# Cisco Unified IP Phone Release Notes for Firmware Release 8.4(1) (SCCP and SIP)

**7971G-GE, 7970G, 7961G-GE, 7961G, 7941G-GE, 7941G, 7931G, 7911G, and 7906G**

**August 25, 2008**

**Figure 1** Cisco Unified IP Phone Screen Changes with Firmware Release 8.4(1)

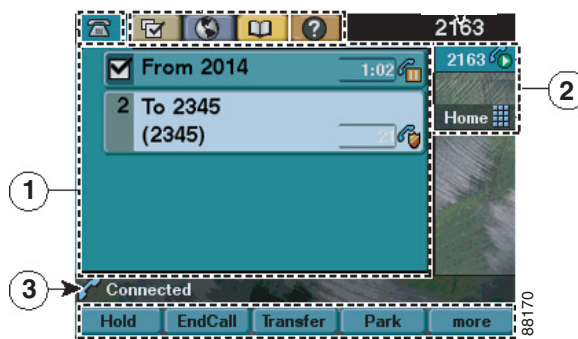
Cisco Unified IP Phone firmware release 8.4(1) introduces three significant appearance changes to the phones:

- Dynamic call window—Minimizes the amount of screen space obscured when an active call is present. See location 1 in [Figure 1 on page 5](#).
- Transparent line label—Minimizes the amount of screen space obscured when a line button has been provisioned with a text label. See location 2 in [Figure 1 on page 5](#).
- Transparent status message line—Minimizes the amount of screen space obscured by the phone status messages by changing from using a shaded background to shadowed text. See location 3 in [Figure 1 on page 5](#).
